OVERHEAD LINE CAMPAIGN CHANGES – DATA SHEET

71	BALANCE WEIGHT ANCHOR GUIDE TUBE SUPPORTS

71 BALANCE WEIGHT ANCHOR GUIDE TUBE SUPPORTS

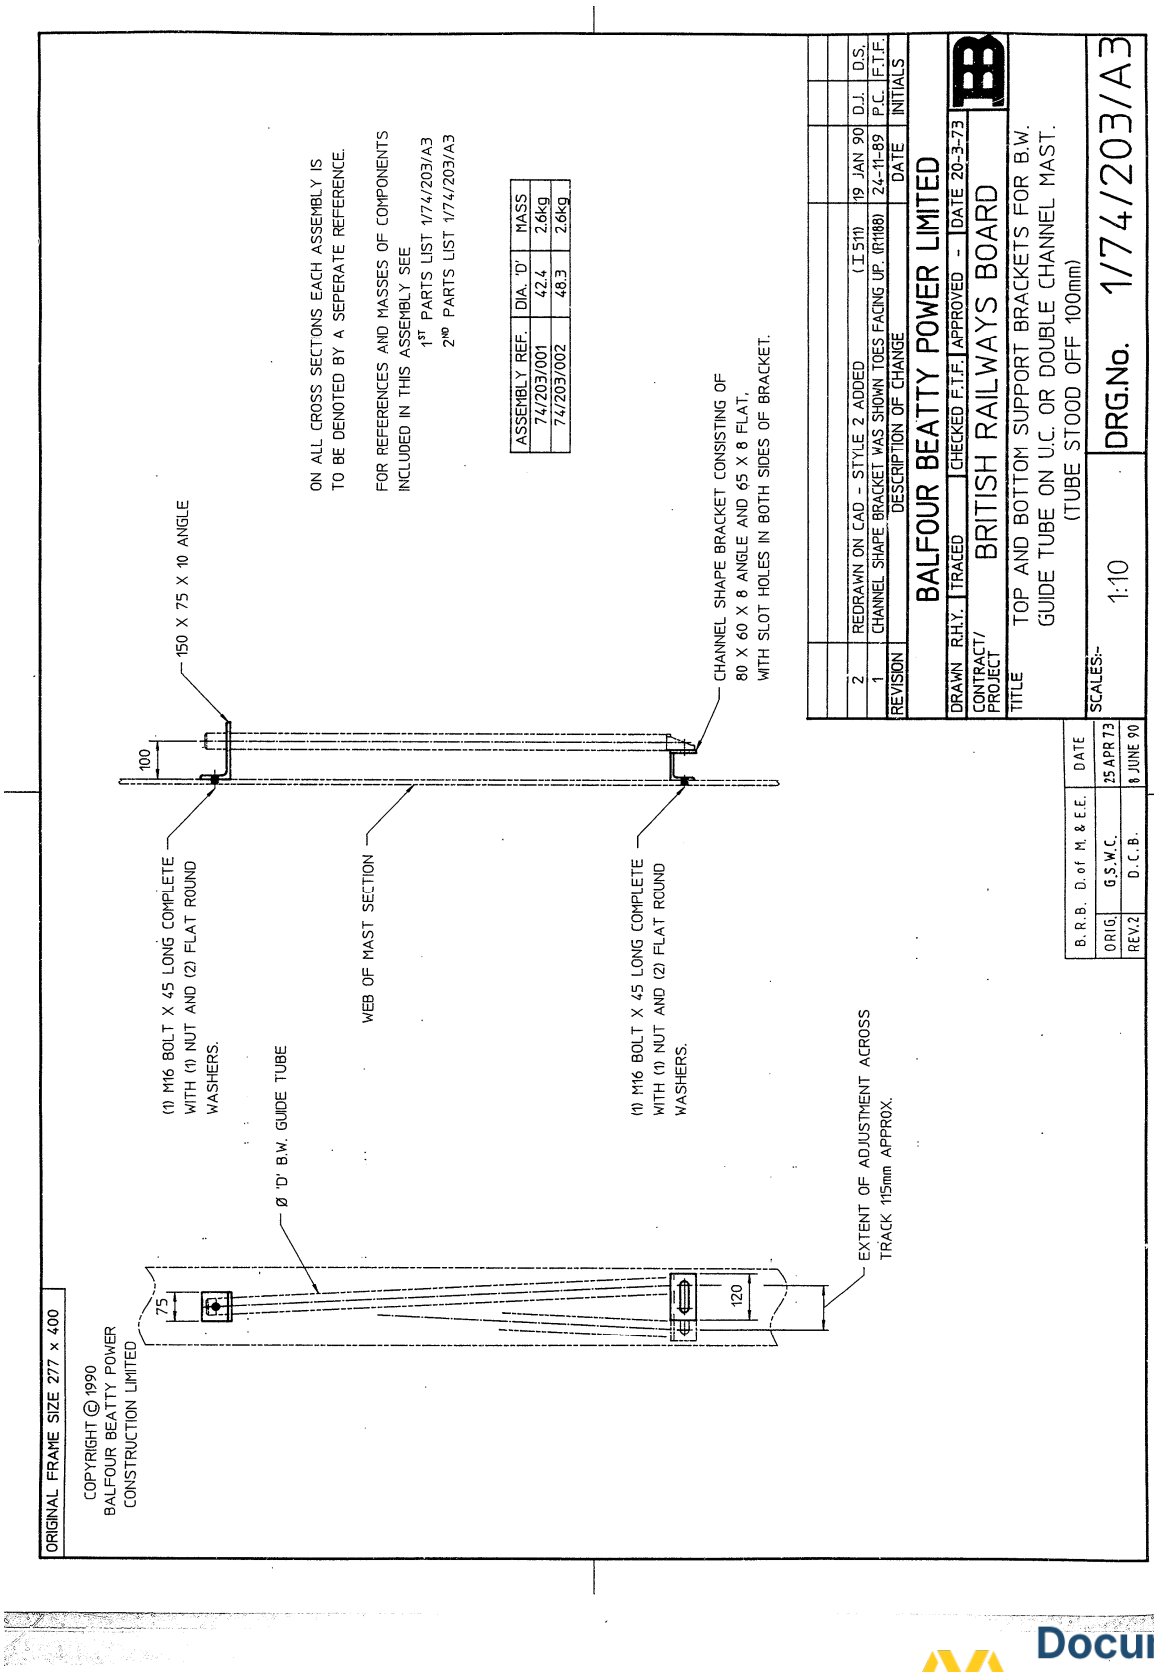
COMPONENT	Balance weight anchor guide tube supports, as shown on 1/074/203
PROBLEM	Under certain conditions, the balance weights come into contact with the square corners of the guide tube top angle support (component drawing 1/171/226) causing them to foul. The affected support brackets are shown on 1/171/226 revision 0 and have square corners compared with the revised bracket shown on 1/171/226 revision 2 that has the corners cut off.
ACTION REQUIRED	Replace with current OLEMI styles to assembly 1/074/203 and component 1/171/226. These have a revised design of guide tube support bracket with the corners cut off. In addition these have a larger tube size (48mm instead of 42mm) to allow for extra long movement of weights. Note that this campaign change was originally issued as a construction site instruction and is reflected on current OLEMI drawings.
